FACTORY DIRECTED MODIFICATION REPAIR AS DIRECTED

OIL LIGHT STAYS ON

HOLE DRILLED THROUGH

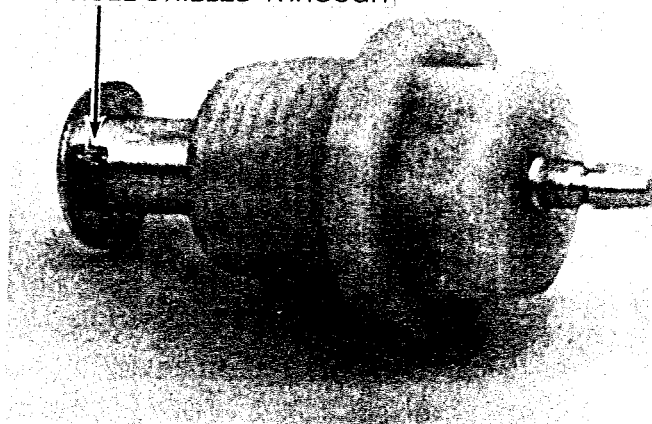
1. Remove the oil pressure indicator switch. Inspect the air-bleed hole in the switch plate.

2. If the hole is partially obstructed, redrill the hole 1.5mm in diameter (1/16 in. or No. 53 drill), as shown. **NOTE:** Do not exceed this diameter, or the warning light will not go out. Install the switch.

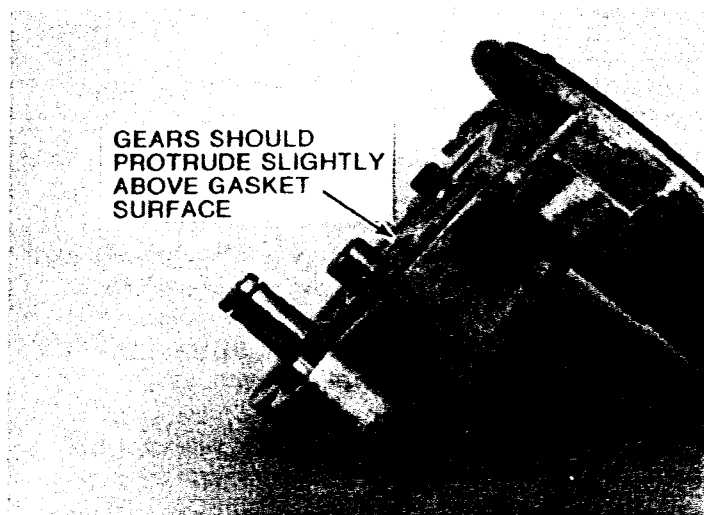
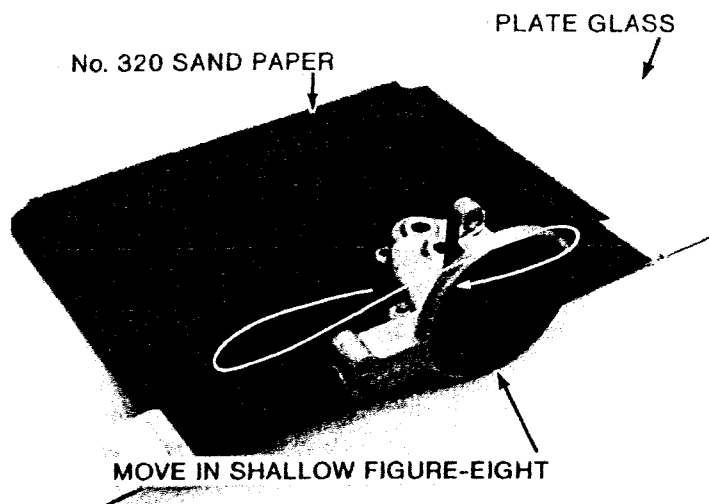
3. Remove the oil pan and the oil pump.
4. Measure the gear-to-cover clearance with Plastigage, as shown. Be sure to lay the plastic strip across the gear tooth with plenty of room for expansion. Consult the Clearance Table to choose the correct gasket and repair procedure.

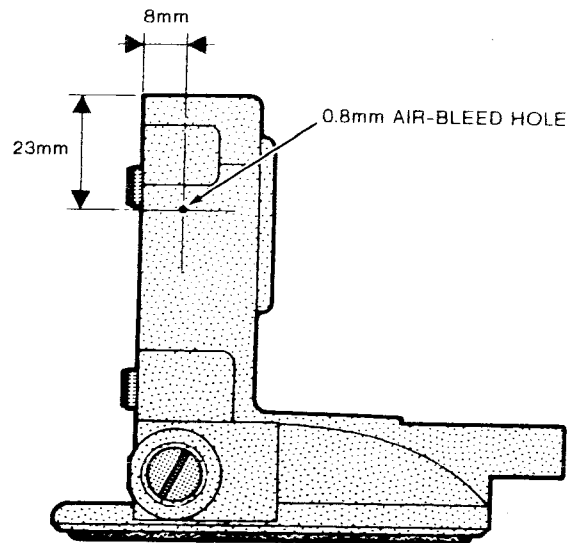
5. Clearance over 0.10mm cannot be corrected with a gasket alone. In this case the pump body must be lapped, as shown. Be careful not to remove too much material. To check, go back to step 4.

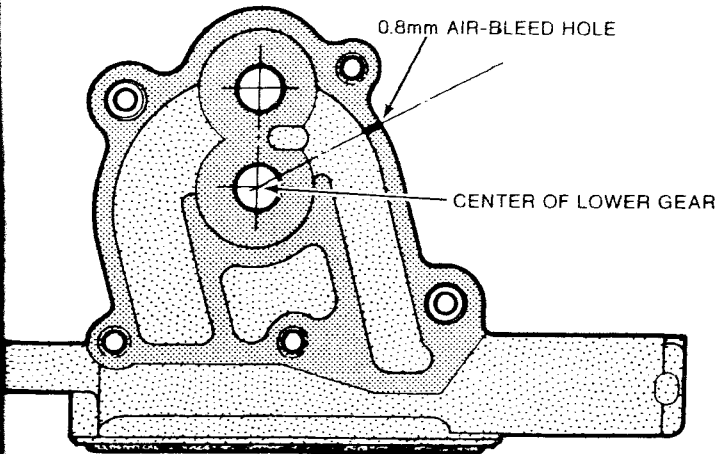
6. To drill the pump air-bleed hole, first remove the gears and stuff rags into the oil passage holes. In the position and direction shown, drill a hole 0.8mm in diameter (1/32 in. or No. 68 drill). This hole should be spaced 8.0mm (0.32 in.) from the gasket surface.

BE SURE TO CLEAN ALL THE CHIPS OUT OF THE PUMP AFTER DRILLING. METAL CHIPS IN THE LUBRICATION SYSTEM COULD CAUSE EXTENSIVE ENGINE DAMAGE.
